Staff Report
City of Richmond, Virginia

Commission of Architectural Review

2. COA-116136-2022	Final Review	Meeting Date: 8/23/2022
Applicant/Petitioner	Suzanne Ross, Highwoods Properties	
Project Description	Replace existing brick patio with stamped concrete pavers.	
Project Location		
Address: 106 Shockoe Slip		
Historic District: Shockoe Slip		
High-Level Details: <ul style="list-style-type: none"> The applicant is proposing to replace the brick pavers on a raised patio (constructed in 1996) with stamped concrete pavers that resemble brick. The pavers will be installed using a pedestal system. The stamp concrete pavers are only proposed on the raised patio located to the east of Shockoe Slip, as indicated on the map to the right. This request is being made to allow access to piping below when maintenance is needed. 		
Staff Recommendation	Approval, with Conditions	
Staff Contact	Alyson Oliver, alyson.oliver@rva.gov , (804) 646-3709	
Previous Reviews	None.	
Conditions for Approval	Staff recommends approval of this request with the following condition: <ul style="list-style-type: none"> Replacement of the existing brick pavers with stamped concrete be restricted to only the raise

Figure 2. Example of proposed concrete paver.

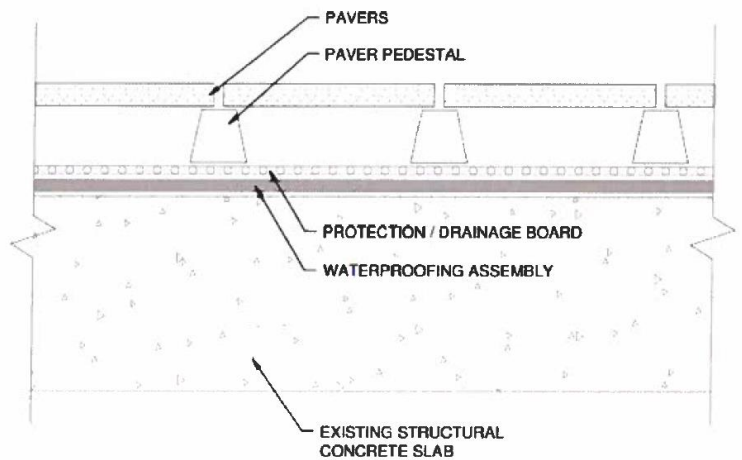
Guideline Reference	Reference Text	Analysis
Standards for Site Improvements , Sidewalks & Curbs, pg. 76	<p>4. <i>Brick or granite pavers are the most appropriate choice in most Old and Historic Districts</i></p> <p>7. <i>Sidewalks and curbs should be built of common building materials found throughout the District. Generally, simple paving designs are more compatible with the diverse building styles and better unify the various elements found on streets throughout Old and Historic Districts. The use of more than two paving materials within an area is discouraged.</i></p>	<p>The applicant is requesting to replace the existing brick pavers used on an elevated plaza that was constructed in 1996. The parking garage below the plaza has experienced several leaks over the years. Each time there is a leak, the bricks must be removed and replaced to perform the necessary maintenance.</p> <p>The applicant is requesting to replace the existing brick pavers with concrete pavers, colored and stamped to look like brick (see Figure 2). The applicant also proposes to install waterproofing to minimize any future leaks. The concrete pavers will be installed on a pedestal system above the waterproofing (see Figure 3).</p> <p>Concrete pavers are not typically an appropriate choice in a City Old and Historic District. However, staff is supportive of this request because the concrete pavers will only be used on the elevated portion of the plaza, which is minimally visible at the pedestrian level (see Figure 1).</p> <p>To minimize the visual impact, <u>staff recommends that concrete pavers only be used on the raised patio located to the east of Shockoe Slip</u>. Sidewalks outside of the elevated plaza and any other elevated plazas on the property are to remain brick.</p>
